## **Amendments to the Drawings**

The attached sheets of drawings includes changes to Figs. 2-4, 7, 10, 12-14. These drawing sheets replace the original sheets including Fig. 2-4, 7, 10, 12-14.

USSN 09/924,294  
Replacement Sheet

FIG. 2

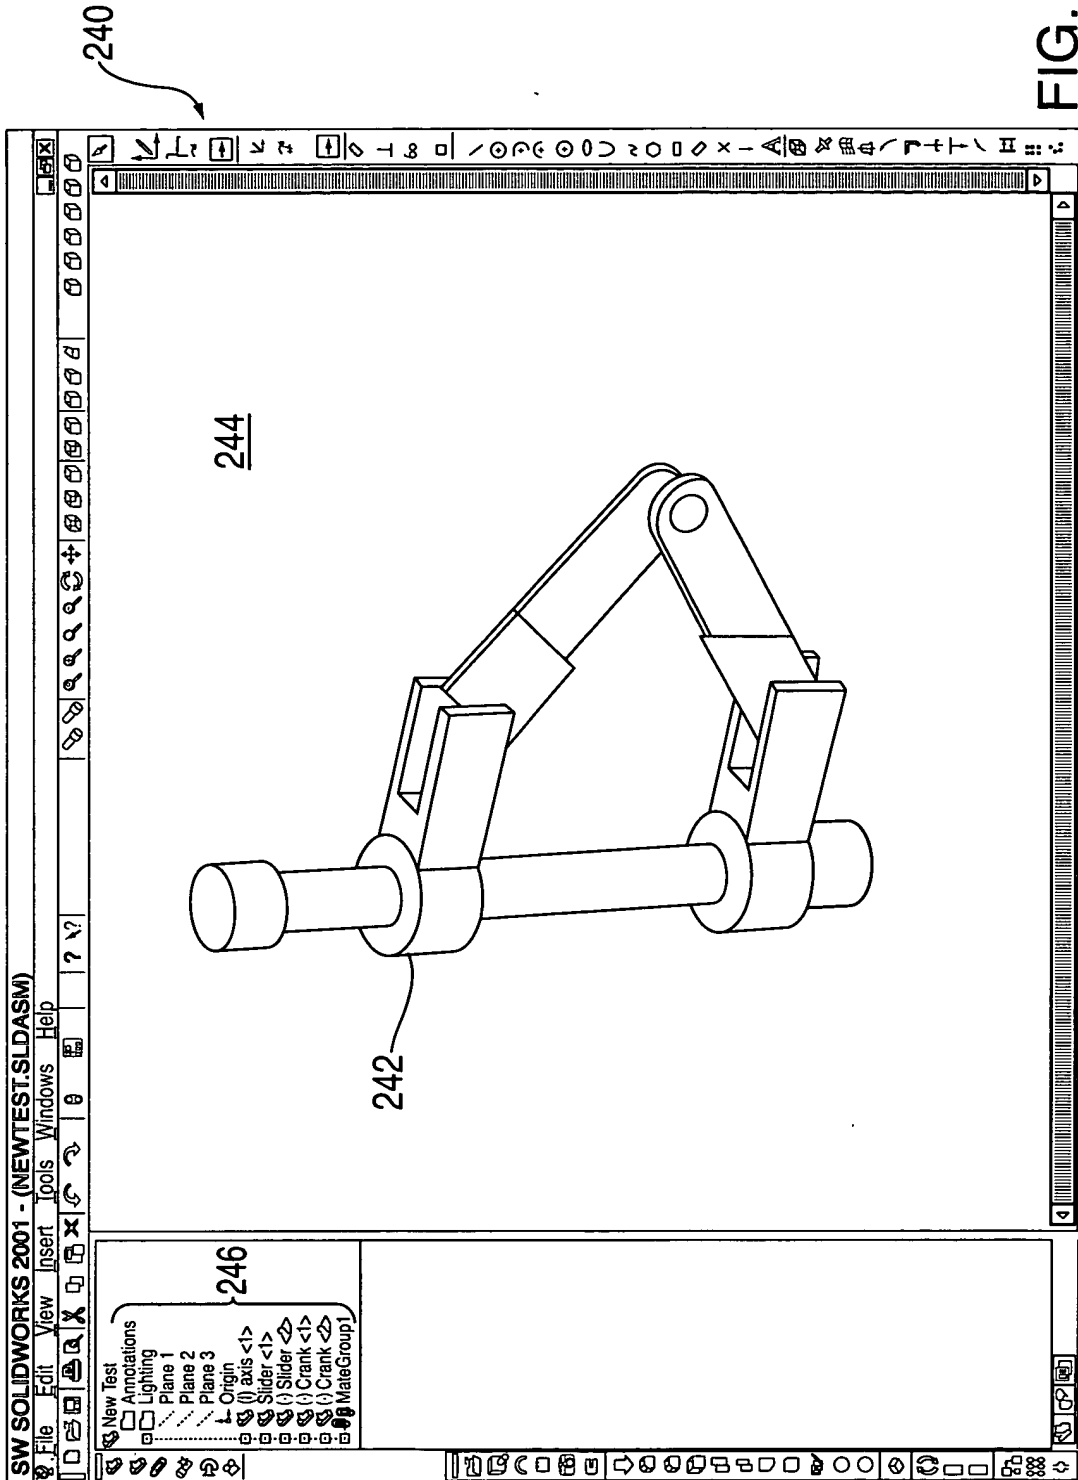
In Fig. 2, the display window has been labeled "240."

FIG. 3

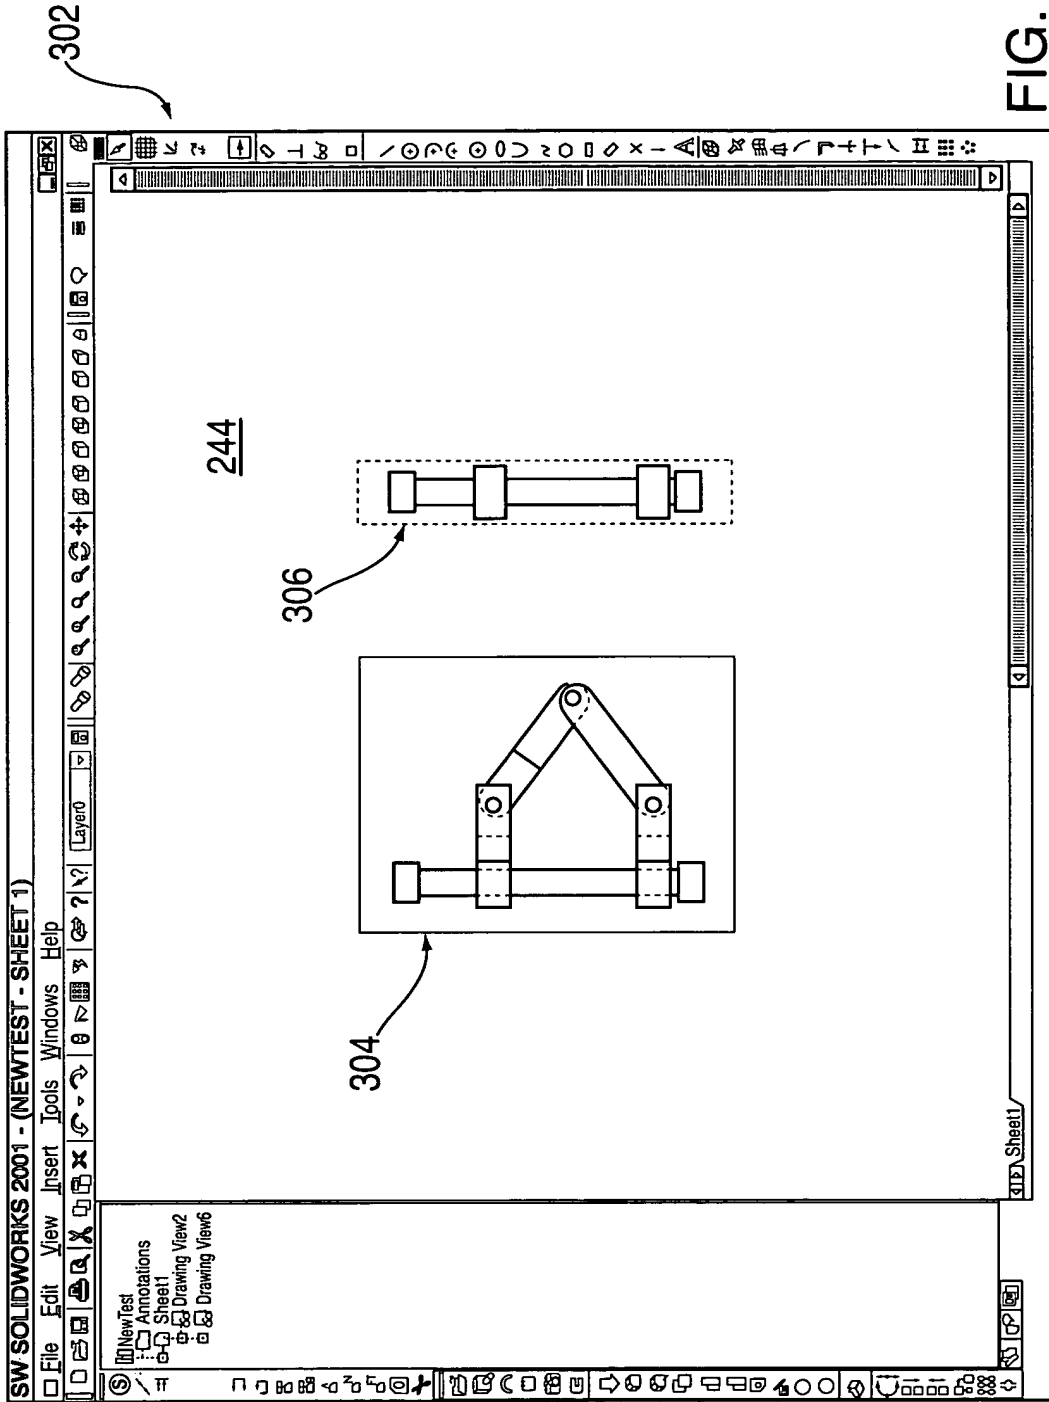
In Fig. 3, the display window has been labeled "302."

FIG. 4

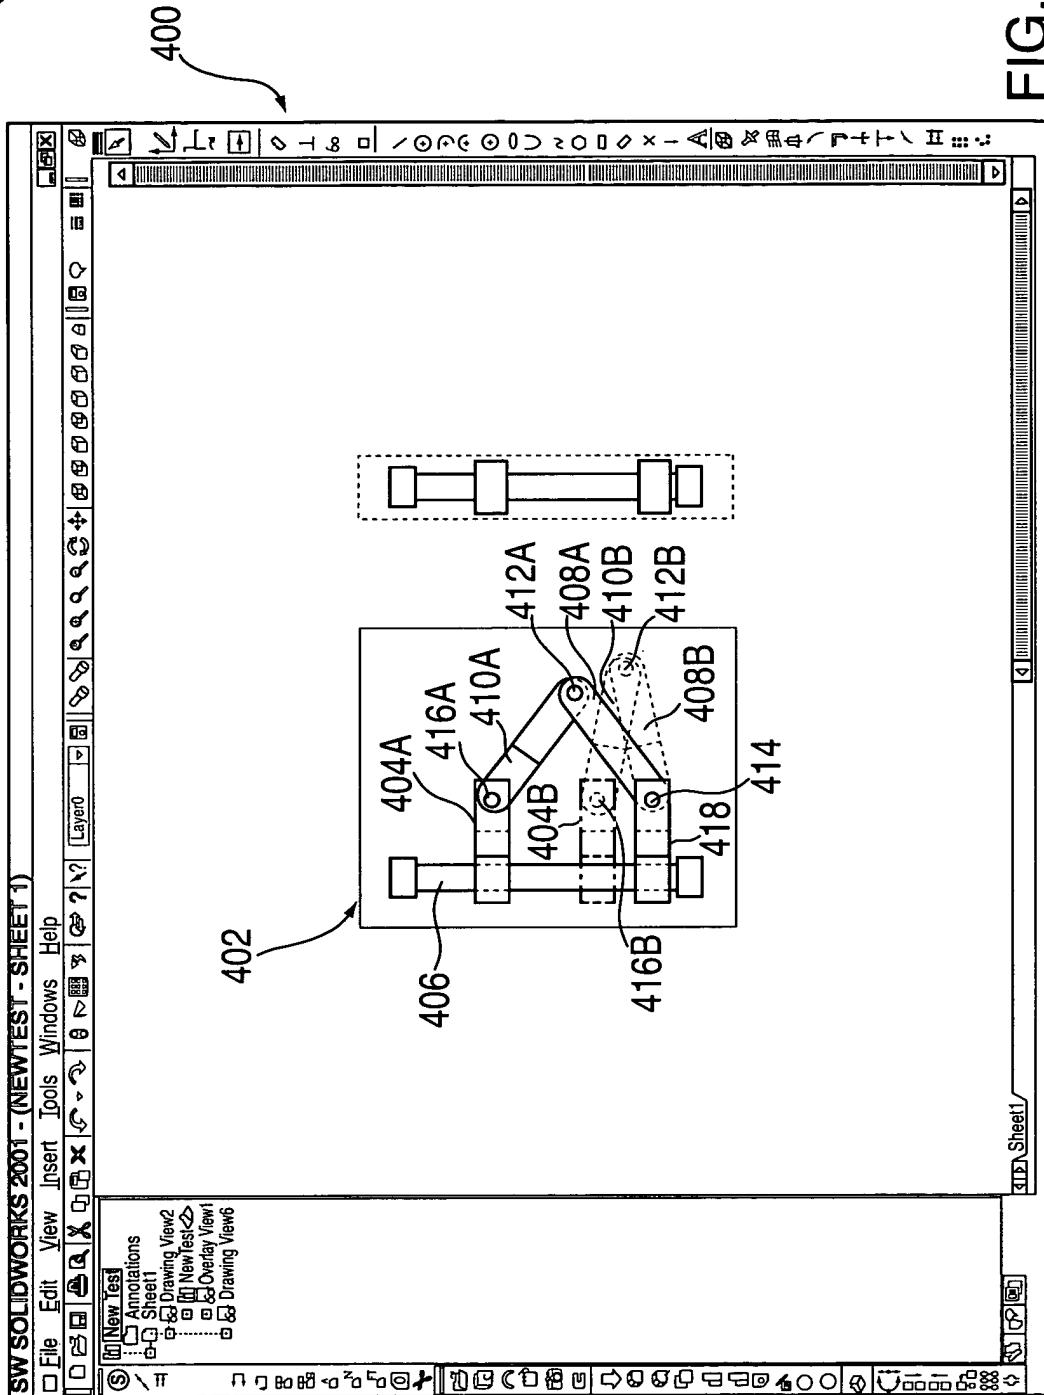
In Fig. 4, the display window has been labeled "400."

FIG. 7

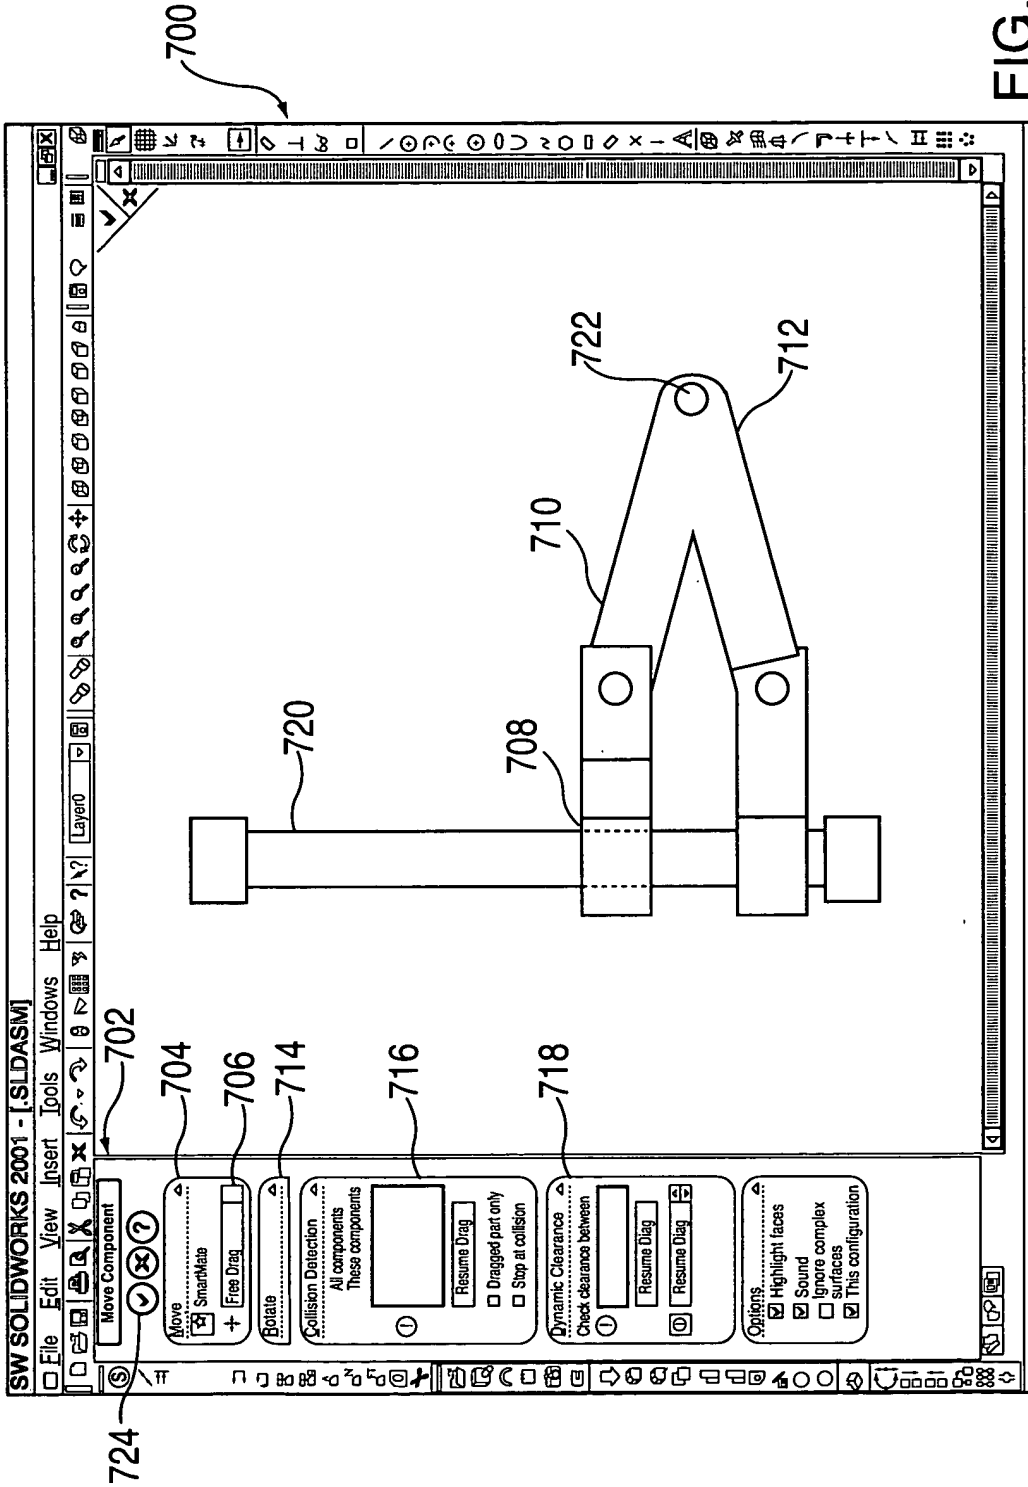
In Fig. 7, the display window has been labeled "700," the shaft has been labeled "720" the pin has been labeled "722" and the checkmark button label has been changed to read "724."

FIG. 10

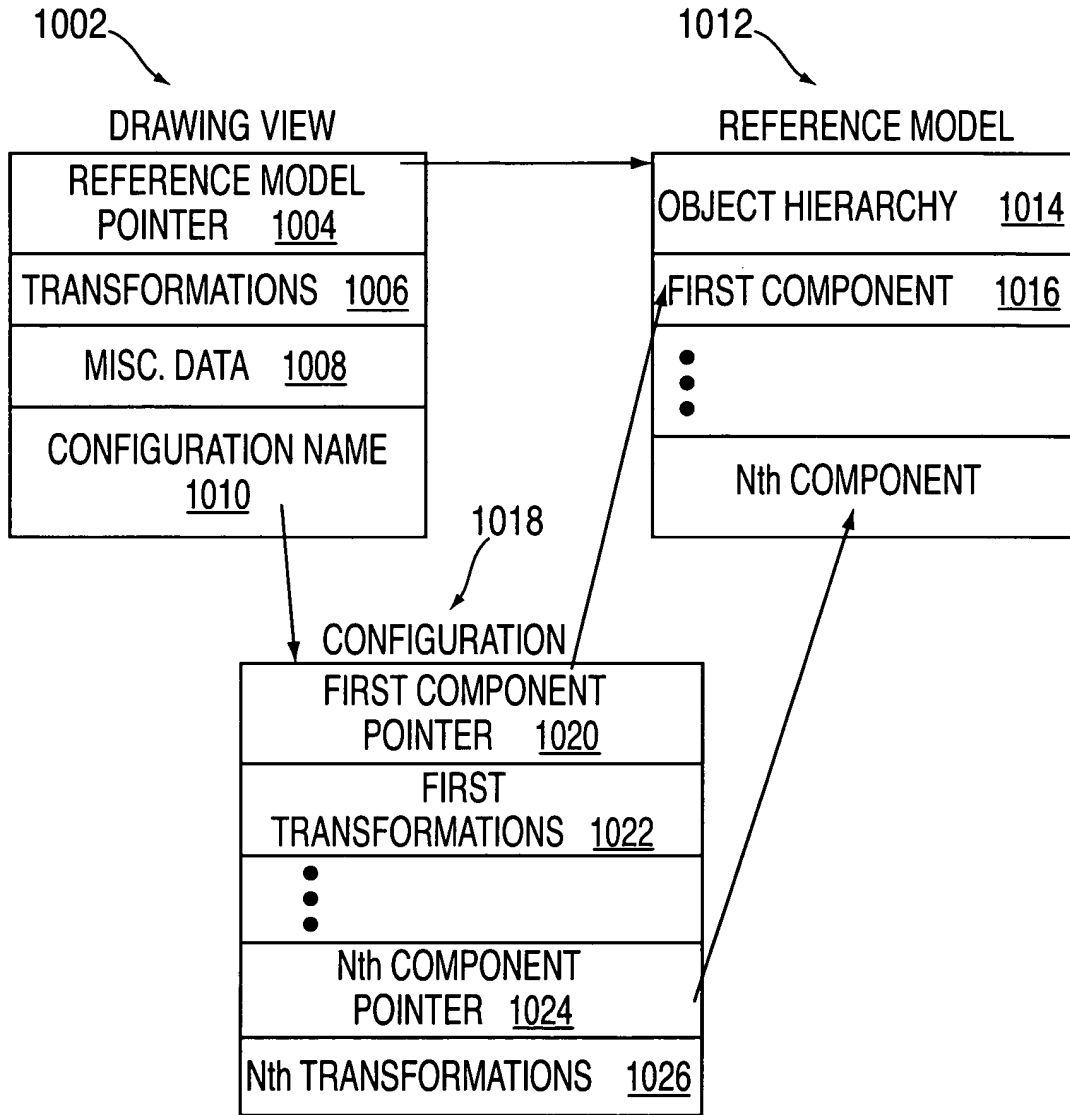
In Fig. 10, an incorrectly drawn arrow connecting boxes 1002 to 1012 has been fixed.

FIG. 12

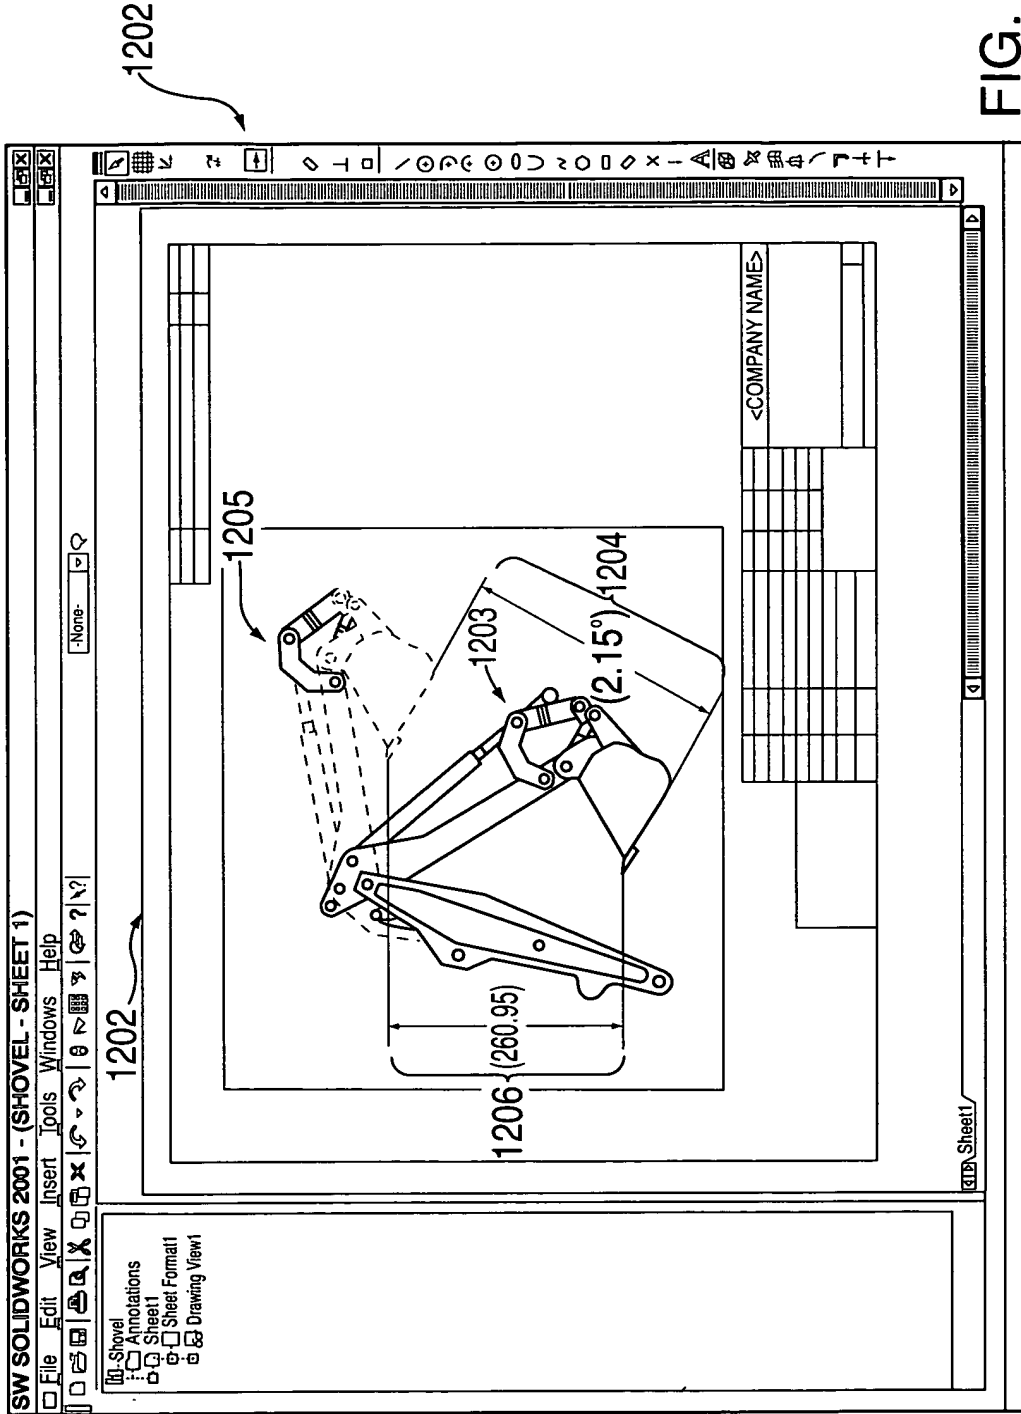
In Fig. 12, the display window has been labeled 1202, the change has been made to an arrows connected to reference labels 1203 and 1205.

FIG. 13

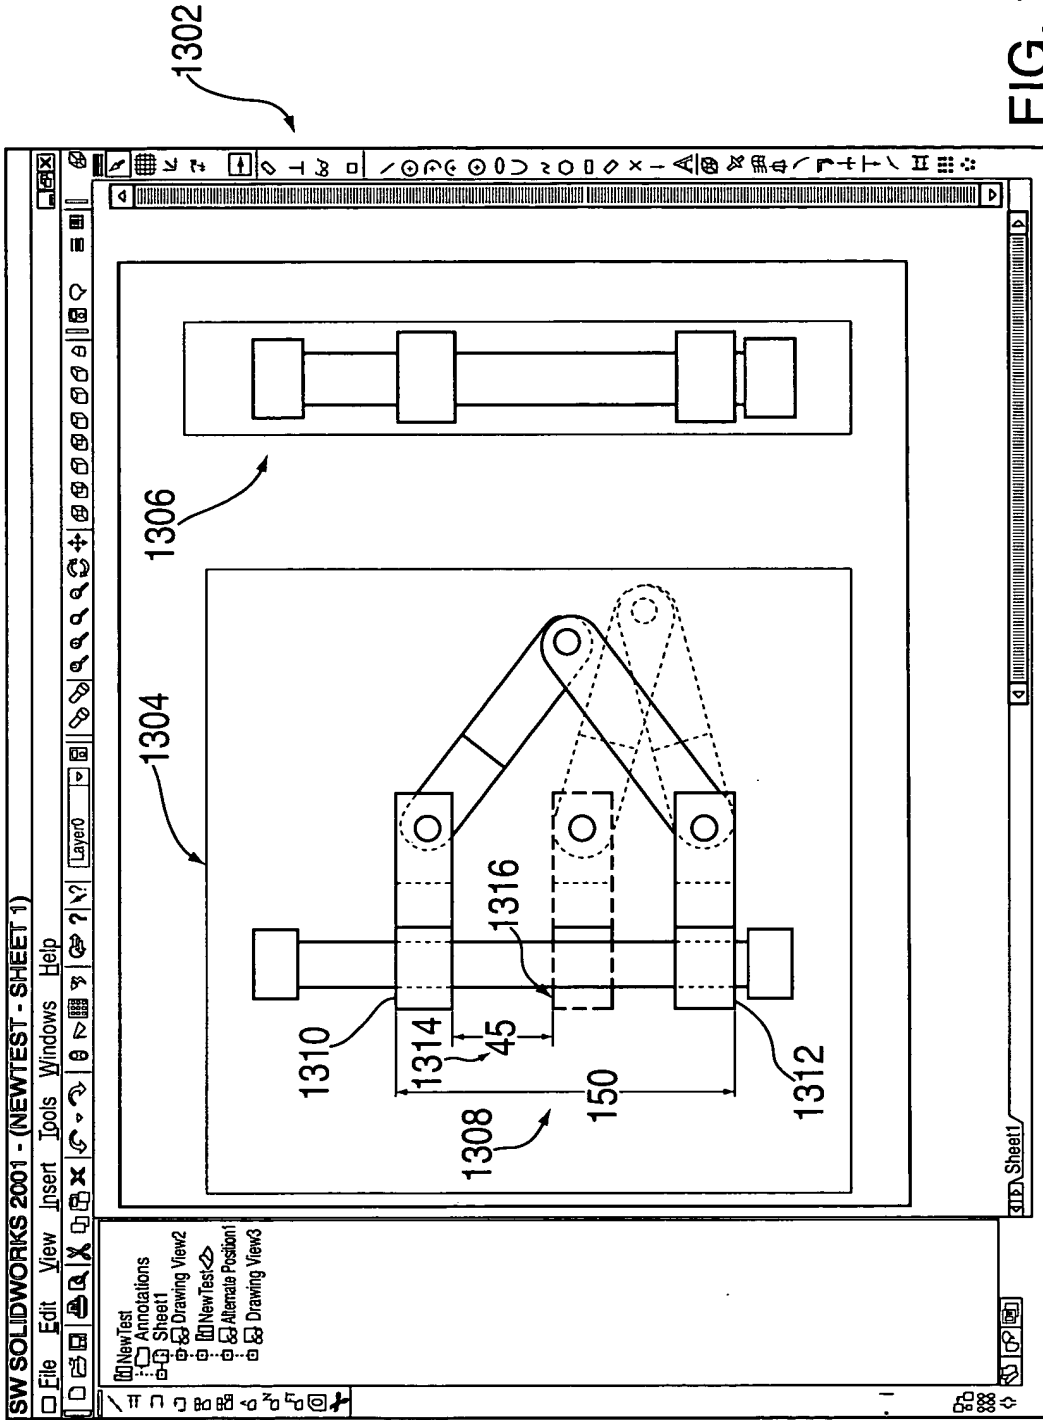
In Fig. 13, the element reference 1302 has been changed to more clearly identify the referenced element.
